ADDENDUM ASSESSMENT REPORT

**DEVELOPMENT APPLICATION
(2016STH035 DA – DA10.2016.304.1)
PROPOSED MIXED USE DEVELOPMENT – RETAIL &
COMMERCIAL PREMISES AND SHOP TOP HOUSING**

**VARIOUS ALLOTMENTS
TERRALONG, AKUNA AND SHOALHAVEN STREETS,
KIAMA**

Prepared for
Kiama Municipal Council

Figure 1: 11 m Building Height Plane for revised proposal.

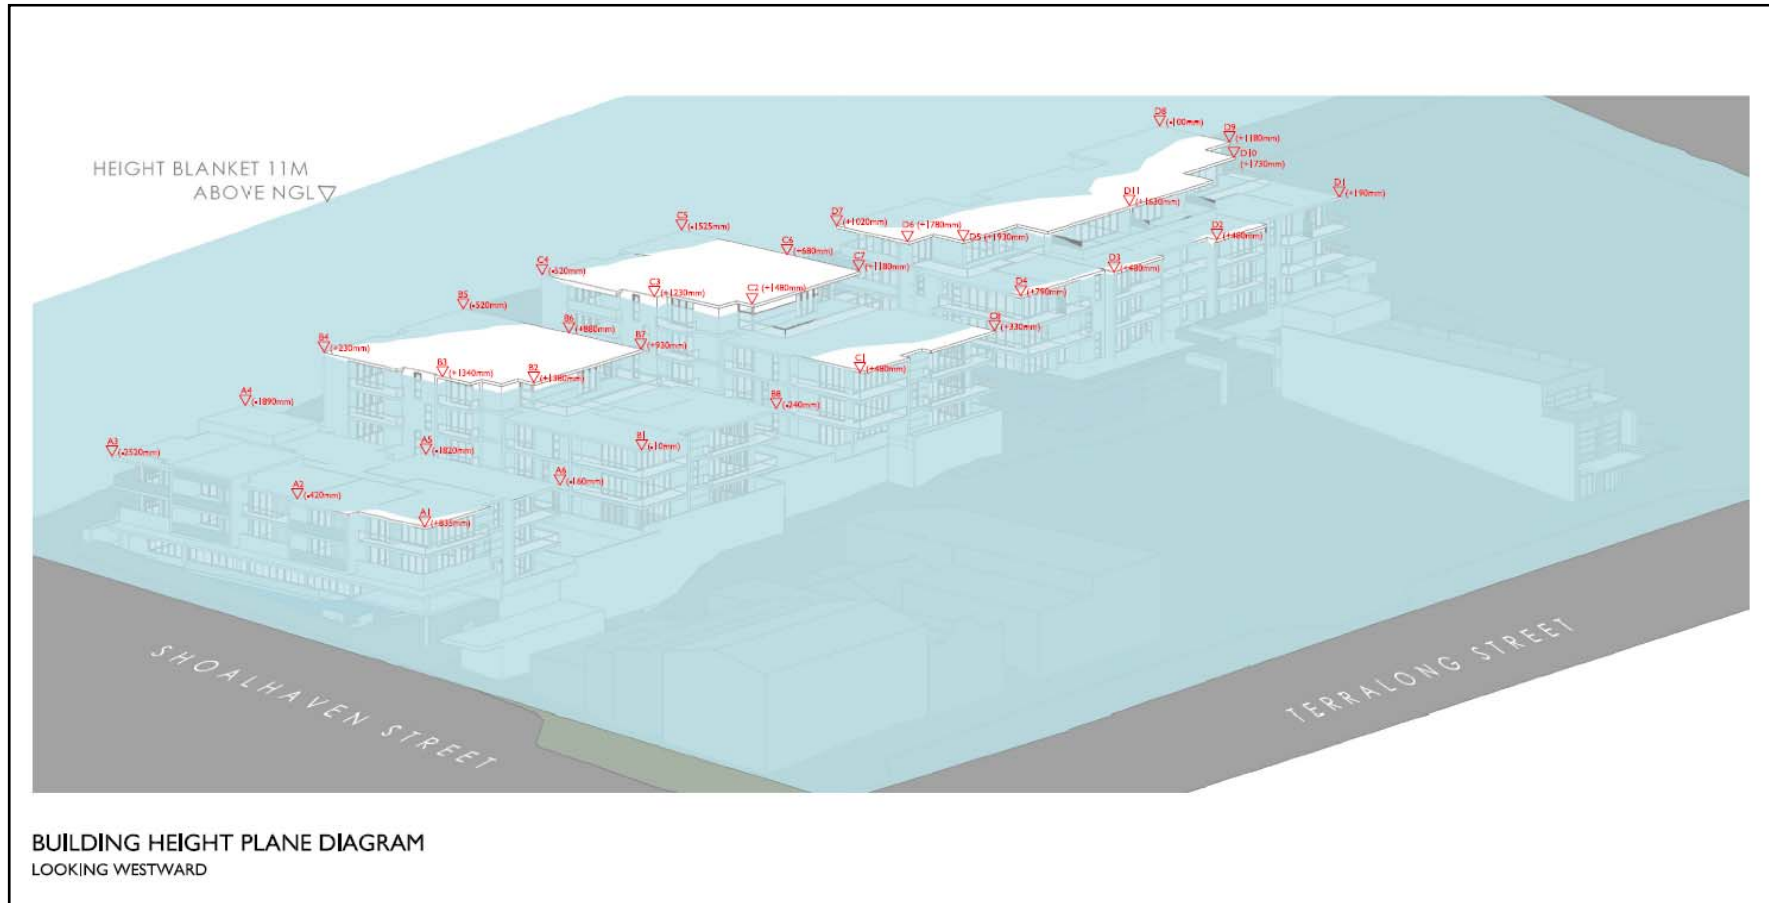
The upper floor level of the revised proposal has been modified with a reduction in extent to which it will encroach the 11 m building height limit for each of the blocks as follows:

- Block A – 835 mm (north-eastern corner);
- Block B – 1380 mm (north-eastern corner) (previously 1850 mm, a reduction of 470 mm);
- Block C – 1480 mm (north-eastern corner) (previously 2780 mm, a reduction of 1300 mm)

- Block D – between 1930 mm and 1730 mm (along northern edge of roof) (previously between 2250 mm and 2350 mm, a reduction of between 420 mm and 520 mm).

The extent to which the revised proposal exceeds the 11 m height limit has further reduced with the extent of encroachment for each of the buildings less than 1500 mm, and only Block D encroaching above 1500 mm encroachment. The greatest encroachment is now 1930 mm at the north-eastern corner of Block D.

The most significant exceedance of the building height limit occurs along the northern edge of the fourth residential level. As with the original proposal the extent of encroachment decreases towards the Akuna Street frontage, where as outlined above the proposal in large part sits below the 11 m building height limit (except for the south-eastern corner of Block B which will slightly encroach 230 mm above the 11 m building height limit). As a result the portion of the development where the encroachment is the greatest is internalised within the development site and set well back from adjoining boundaries. This is particularly the case with the revised proposal with the removal of northern units from Blocks B and C, and the reduction in area of the upper level of units within Block D & E. By setting back the upper level from the northern boundary the extent to which the development encroaches above the 11 m building height limit has been reduced (Refer **Figure 1**). As a result the proposal, despite exceeding the 11 m building height limit will not create adverse impacts to the surrounding locality in terms of overlooking or loss of sunlight.

In my view the extent to which the revised proposal now exceeds the 11 m building height is more acceptable compared to the original proposal.

Figure 3: Revised Shoalhaven Street Elevation.

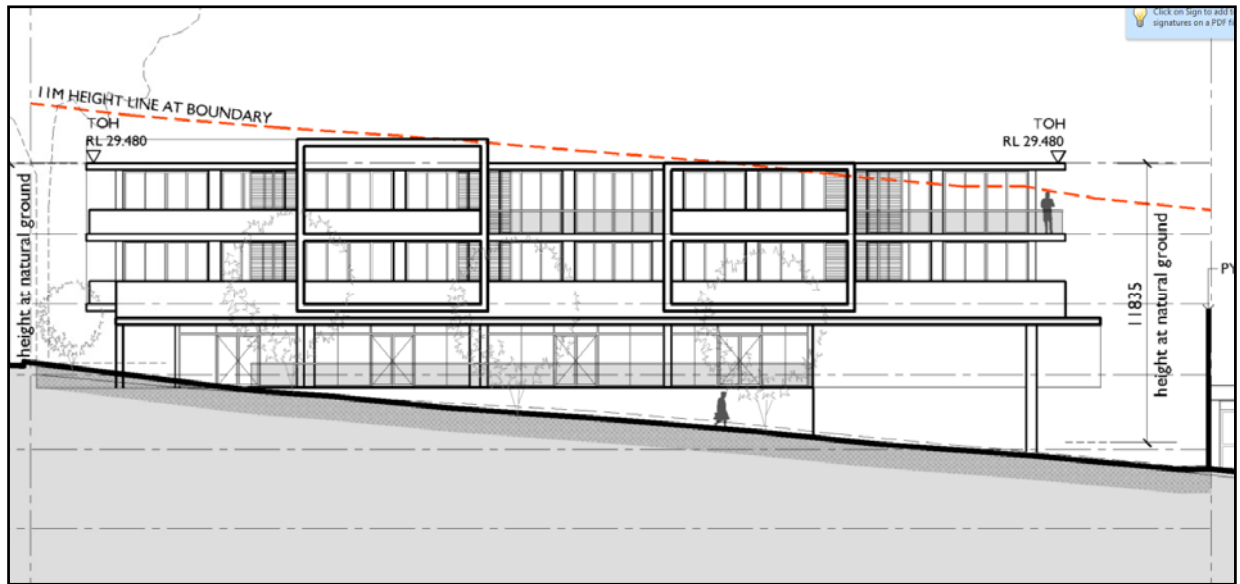
The revised proposal has amended the elevation to Shoalhaven Street to provide more vertical articulation to this elevation when compared to the original proposal.

The original Shoalhaven Street elevation provided a very horizontal articulation as shown in **Figure 2** below:

The revised proposal provides a slight architectural refinement that seeks to provide a more vertical proportion to this elevation as shown in **Figure 3** below:

The revised proposal does provide less of a horizontal articulation compared to the original proposal and a slightly more vertical proportion to this elevation. With the selective use of external materials and colours the development should be able to provide an elevation which better reflects the traditional vertical articulation of development associated with the Kiama Township.
